Regency Court Homeowners Association

RE: Regency Court Homeowners Association's Approval of Proposed Lot Split and Development of 120 Oak Meadow Drive Los Gatos, CA 95032

July 30, 2024 – Below is the Regency Court Architectural Committee 'Findings and Recommendations' to Regency Court Board. Not in numerical order of importance.

CONSTRUCTION SITE ACCESS

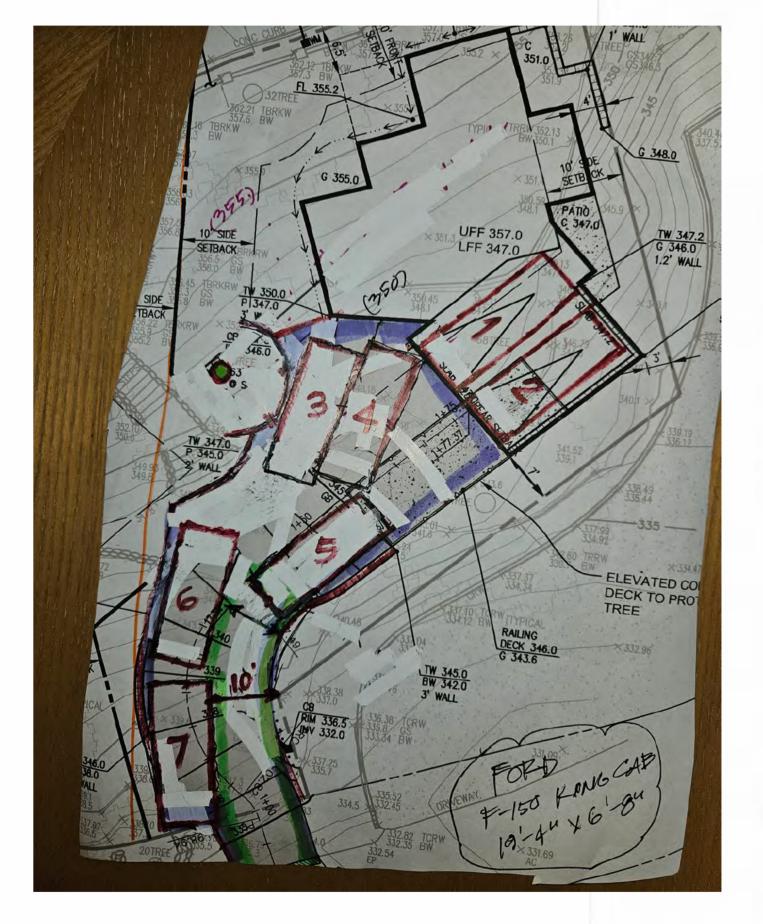
9) The Committee requests Town to communicate the days and start/stop hours of construction. Create a plan and communicate to HOA where workers and construction vehicles will park (there is NO available parking on Oak Meadow Drive either upper or lower). Parking cannot occur in any HOA designated spots without prior written

communication and approval from the Regency Court HOA Board (see Board e-mail addresses, below). All construction traffic must enter from Blossom Hill Road.

See Construction Site Access plan in upper left corner of A-1 including note that HOA to be provided with contractor, owner and architects phone numbers.

A-1 SITE PLAN

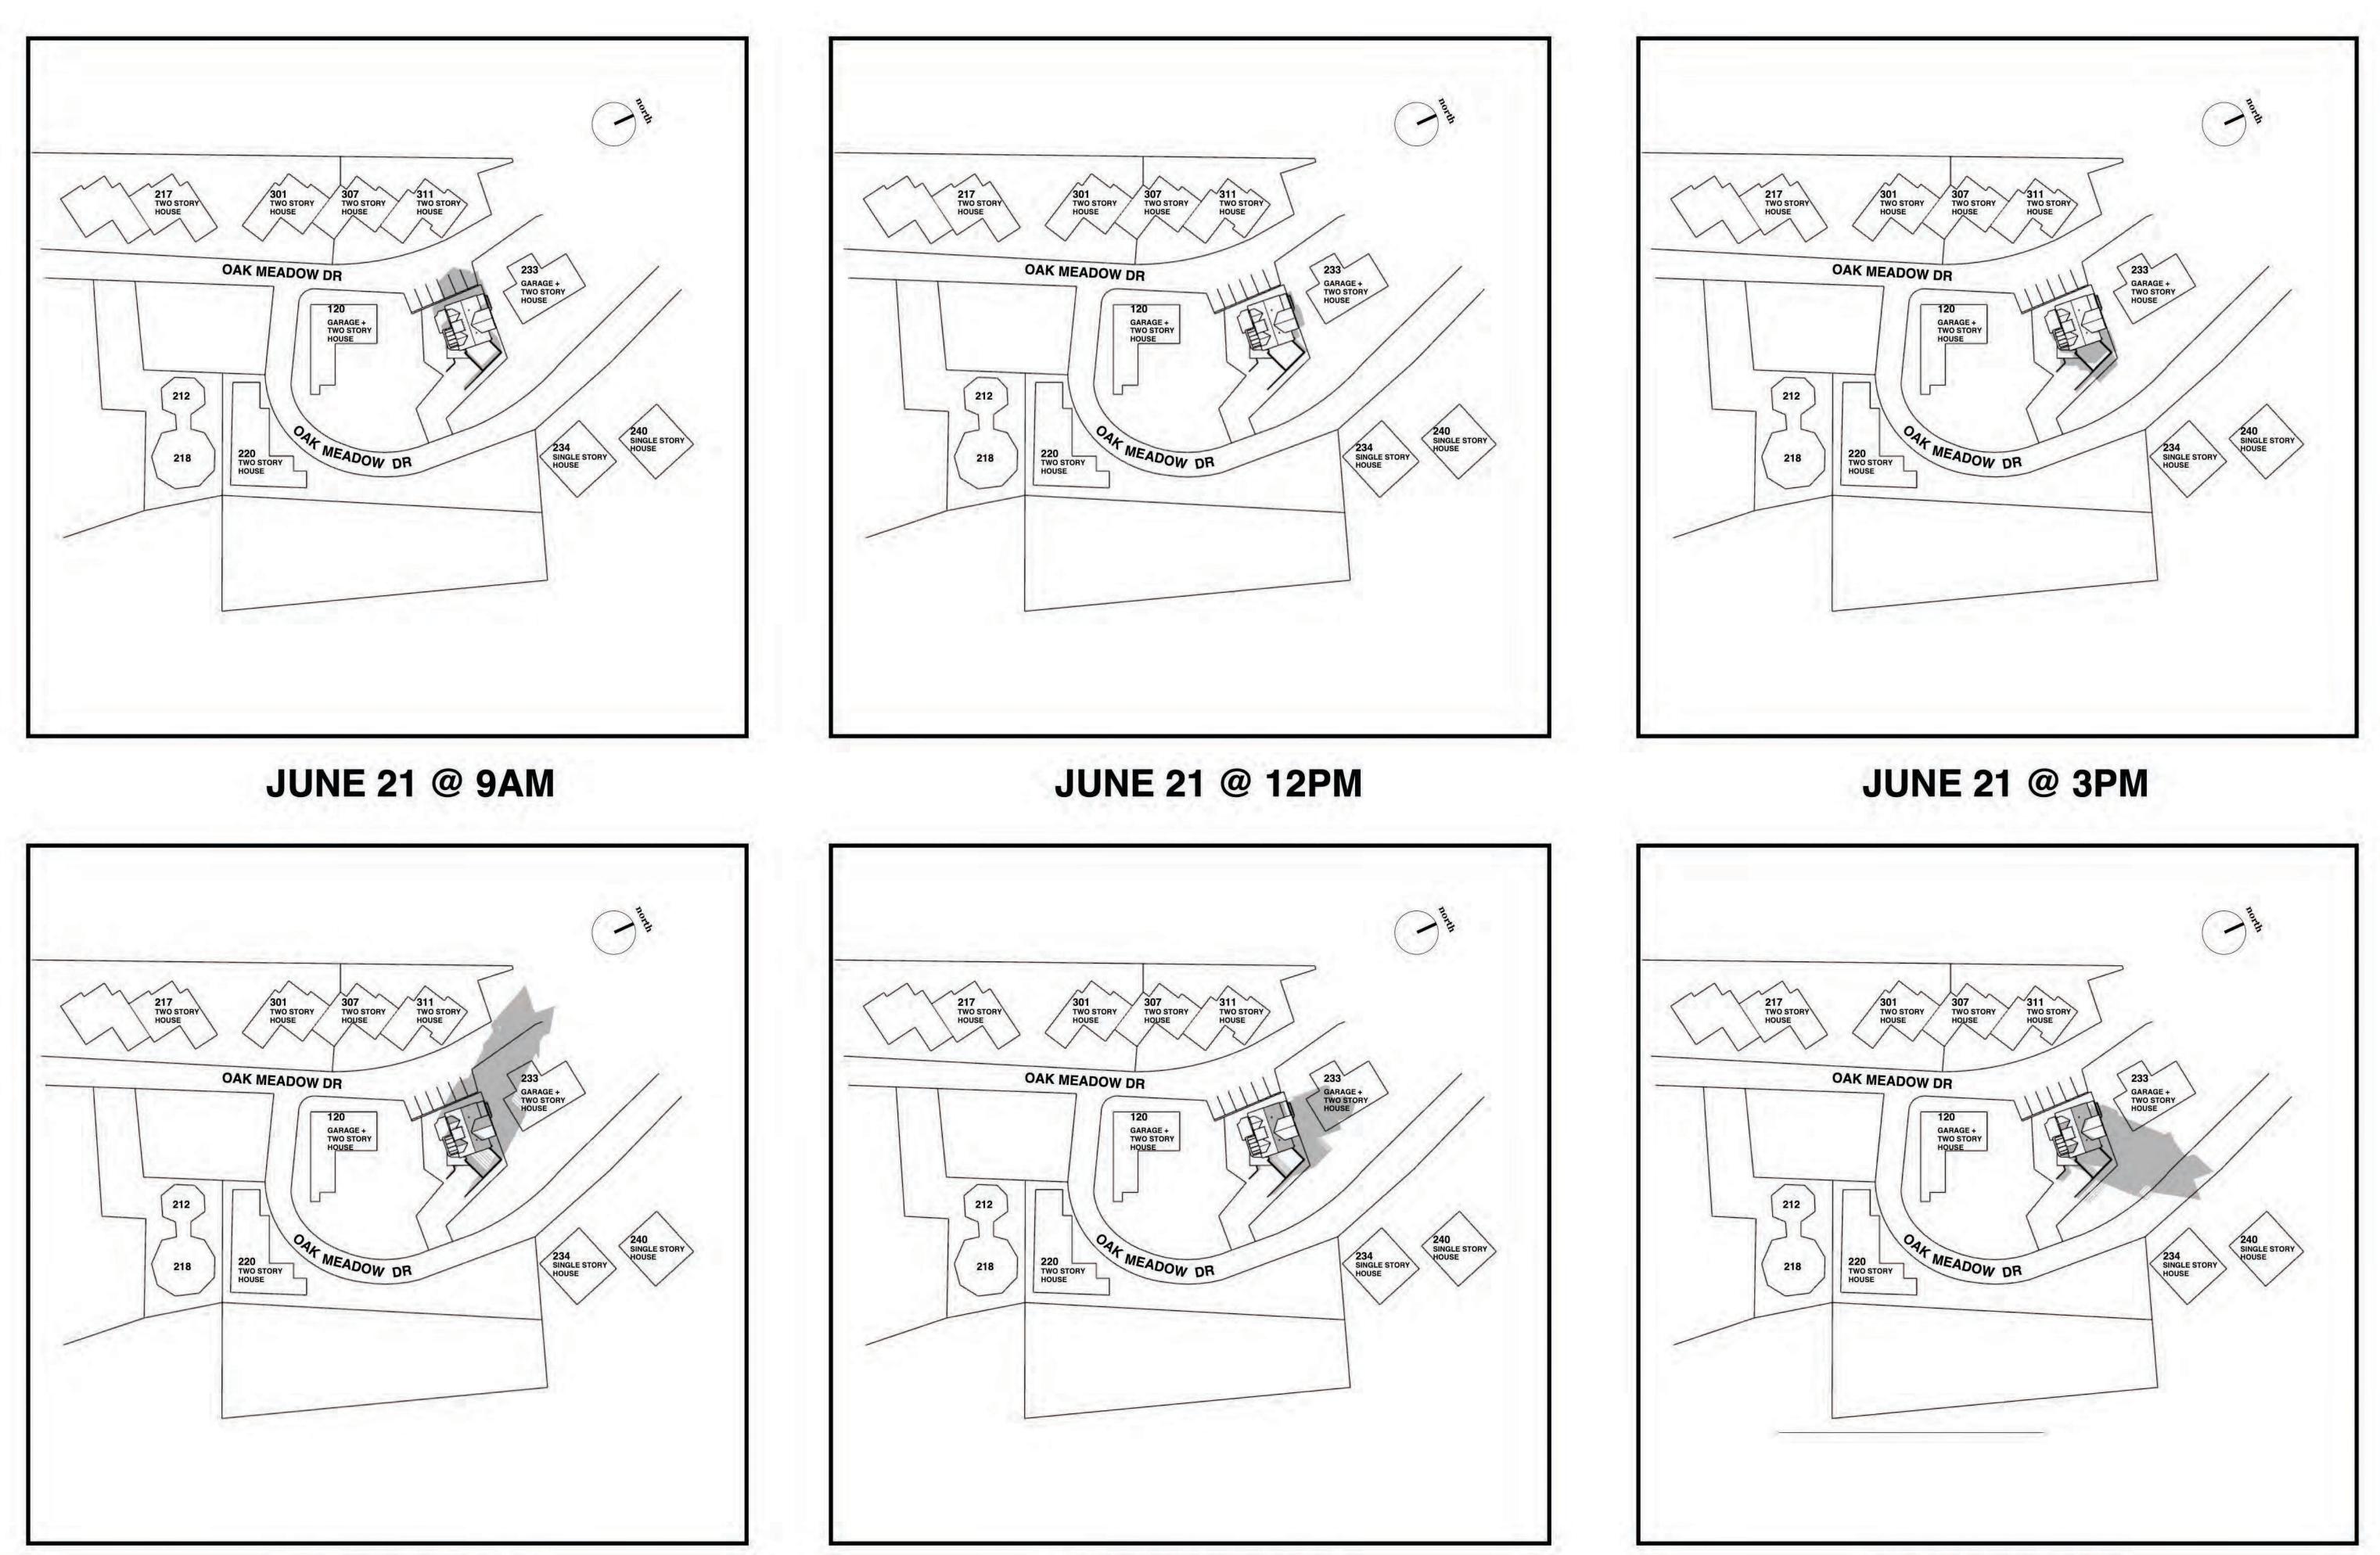
- 3) Approval must include a requirement that current or future owners cannot take down the brick wall or make any modifications to the brick wall now and in the future. Plan already indicates that it will be retained see A-1 (E). Language can be expanded in CC&Rs if necessary. Wall to be extended north using same vertical siding as 2nd story of house and privets to be retained. See A-1.

5) No exit from behind the house to the front/upper portion of Oak Meadow Drive. All occupant ingress & egress needs to occur from lower Oak Meadow Drive via newly built driveway. No ability to exit through the door in the wall along upper Oak Meadow Drive.

- 7) The HOA Board requests confirmation that garbage cans for the new property must be located on the backside by the driveway entrance (lower Oak Meadow Drive). No additional garbage, recycle or yard waste bins will be placed in front of the 120 Oak Meadow Drive residence/road. Agreed - See note at the bottom of A-1 indicating garbage service to be located at bottom of driveway per HOA.

10) Erect a construction barrier to protect dirt and dust from impacting newly painted HOA residences. Install prior to commencement of construction. A construction debris barrier will be erected on upper Oak Meadow to limit dust – See upper A-1. Best construction practices to be followed to control dust including periodic water spraying. Hand digging around oak trees will also limit dust.

Owner understands HOA concern and believes signs recently posted by HOA provide adequate deterrence. As indicated in 3) above, fence to be extended north of existing brick wall. As shown in A-1 and agreed to in meeting, fence will have small gate opening to landing of Lot 12 stairs to allow owner to access property in front of wall/fence for maintenance including trimming of ivy, weeding and leaf blowing. This is needed so owner will not be required to walk down the driveway, walk up the hill to the top of Oak Meadow and around the corner carrying gardening equipment.
